Eric A. Larson
Site Vice President724-682-5234
Fax: 724-643-8069August 8, 2014
L-14-258ATTN: Document Control Desk
U. S. Nuclear Regulatory Commission
Washington, DC 20555-0001**SUBJECT:**Beaver Valley Power Station, Unit No. 2
Docket No. 50-412, License No. NPF-73
Response to Request for Supplemental Information Regarding Spent Fuel Storage Pool
Minimum Inadvertent Drainage Elevation License Amendment Request
(TAC No. MF4213)

Response to July 24, 2014 Request for Supplemental Information
Page 1 of 5

By letter dated June 2, 2014 (Accession No. ML14153A388), FirstEnergy Nuclear Operating Company (FENOC) requested an amendment to the operating license for Beaver Valley Power Station, Unit No. 2 (BVPS-2). The proposed amendment would correct the minimum drain elevation for the spent fuel storage pool specified in BVPS-2 Technical Specification 4.3.2, "Drainage."

Figure 1
Dose Rate at Fuel Building Operating Floor Elevation,
As a Function of Water Coverage

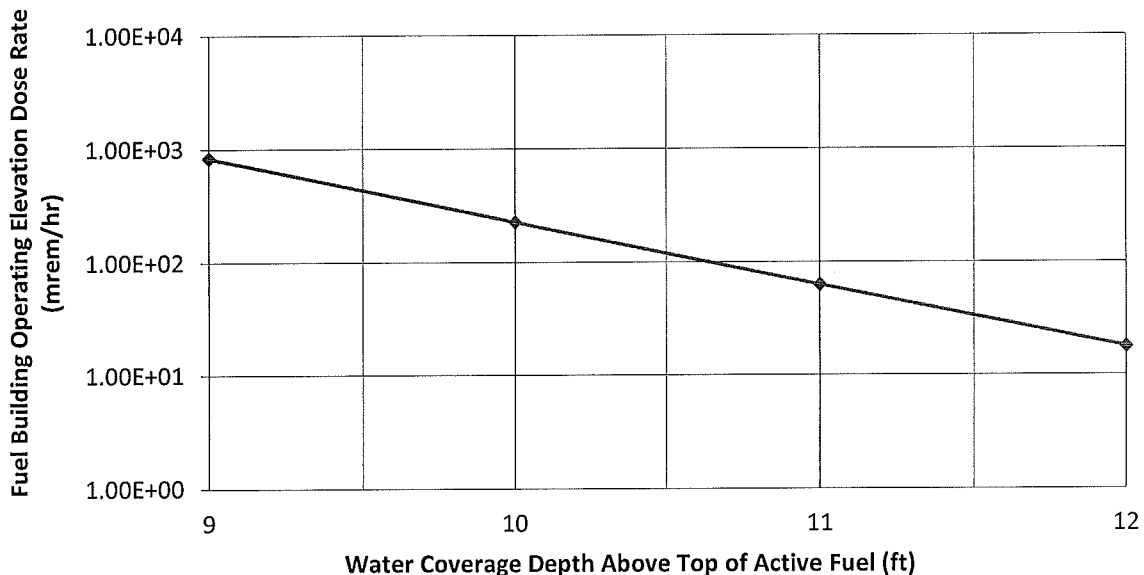
1) A calculation sheet which cites the appropriate Regulatory Guide methodology and provides the calculation that demonstrates an estimated dose rate of approximately 280 millirem per hour for a person located at the fuel building operating floor elevation, directly above freshly discharged fuel assemblies stored in the spent fuel storage pool with the pool water level reduced to the 750 feet, 10 inch elevation.

Figure 1 presents the calculated dose rate at the fuel building operating floor elevation, directly above the freshly discharged fuel assemblies, as a function of water coverage above the top of the active fuel.

The exponential function least squares curve fit of the Figure 1 dose rate versus water coverage data is given in Equation 1.

$$DR(x) = (8.3326E07) e^{-1.2806x} \quad \text{Equation 1}$$

The dose rate at the fuel building operating deck elevation, 767 feet – 10 inches, is estimated by Equation 1 to be approximately 280 millirem per hour with the active fuel water coverage decreased to 9.84 feet (3 meters). Three meters of water coverage was selected for evaluation because it bounds the minimum water level of approximately 9.89 feet over the top of the active fuel that is present when the spent fuel storage pool is drained to elevation 750 feet – 10 inches.

The critical design inputs and assumptions that resulted in the development of the Figure 1 dose rate curve are as follows:
